PROPOSED WESTERN SYDNEY ORBITAL

Director-General's Report
Section 115C of the
Environmental Planning and Assessment Act 1979

February 2002

Figure 5.6a Land Zonings and Flooding Impacts – 100 Year ARI 2 Hour (Source: RTA)

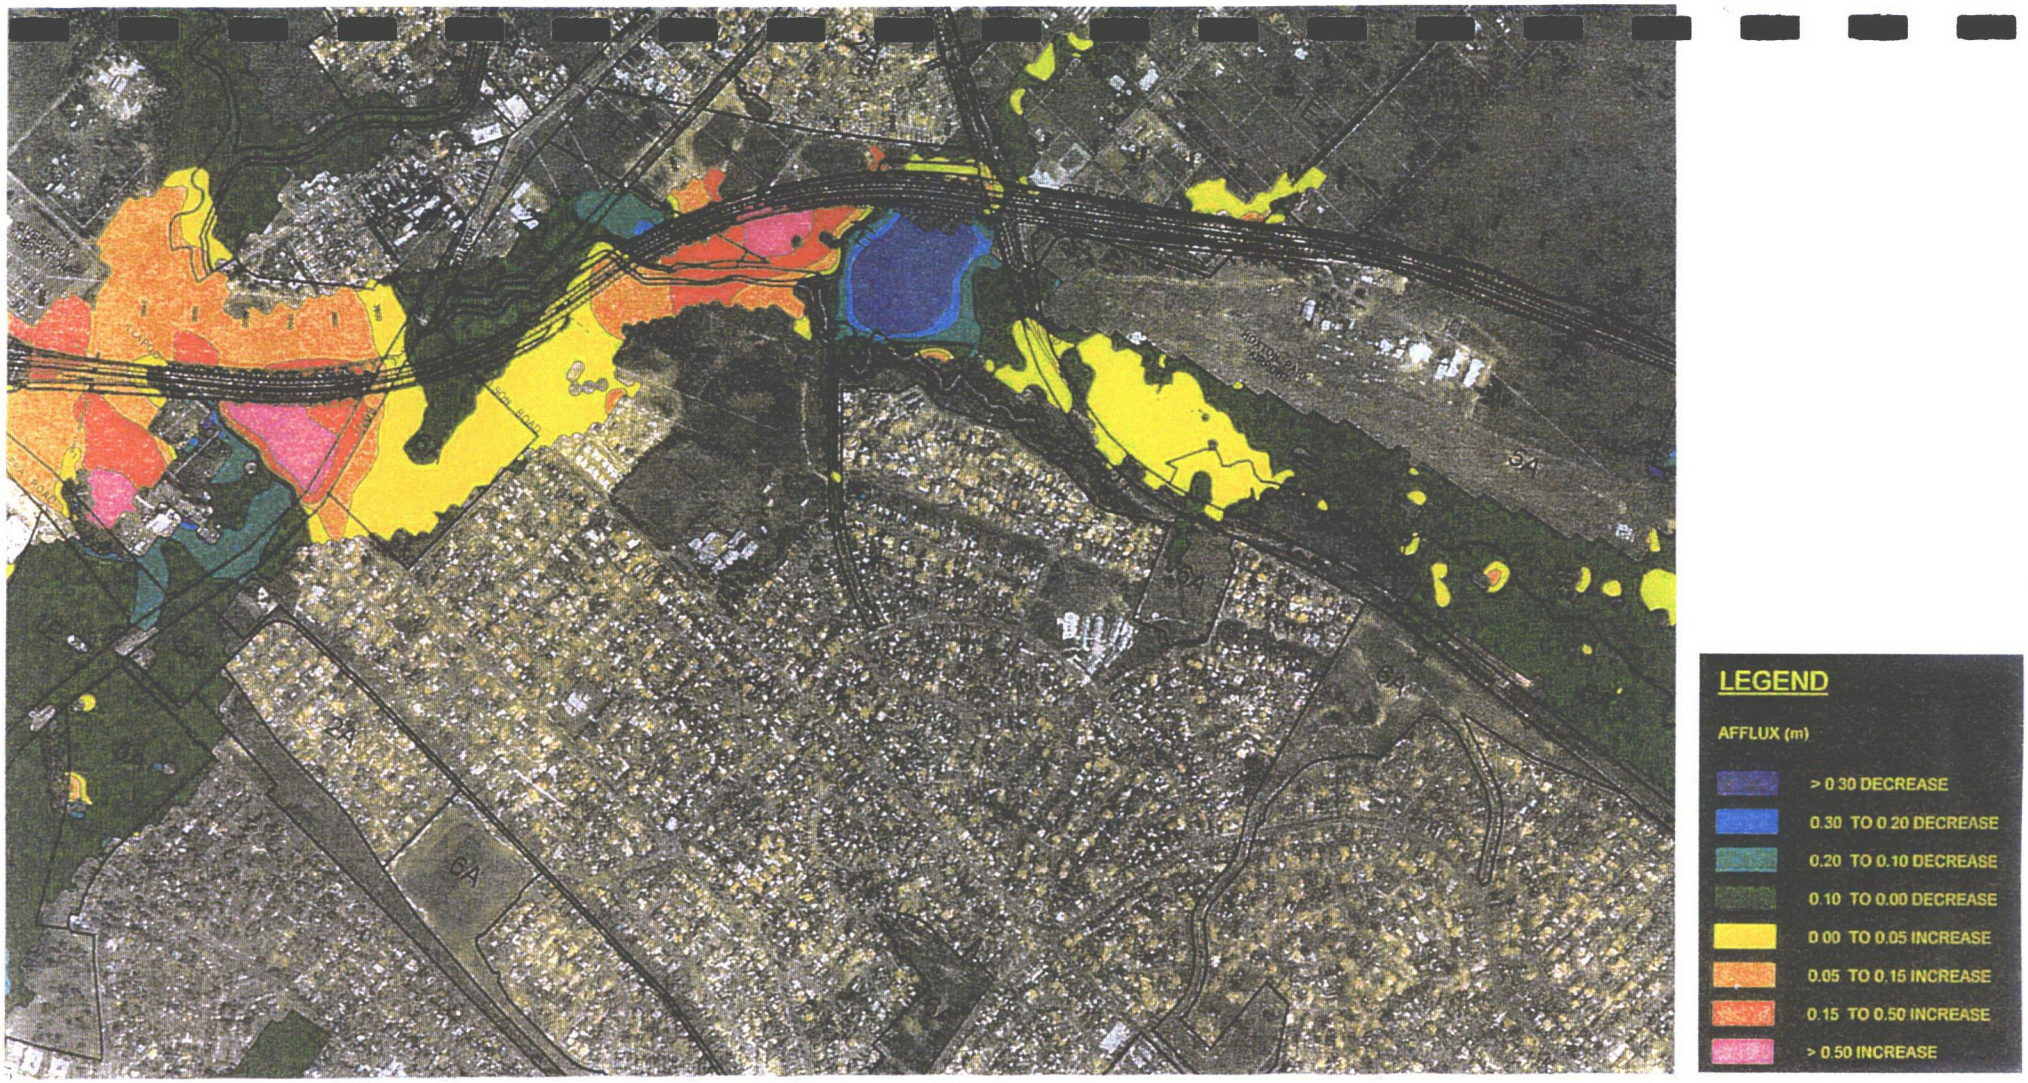
To assist in the application of these criteria with respect to existing and future potential land use, the land zonings have been superimposed over the flooding impacts (afflux) for the 2h 100y ARI and 9h 100y ARI and are shown in Figures 5.6 (a)+(b) and 5.7 (a)+(b). Modelling of the concept design shows that some localised areas show significant increased afflux which, the report suggests would need to be reduced to acceptable levels in the detailed design stage. These areas are located at:
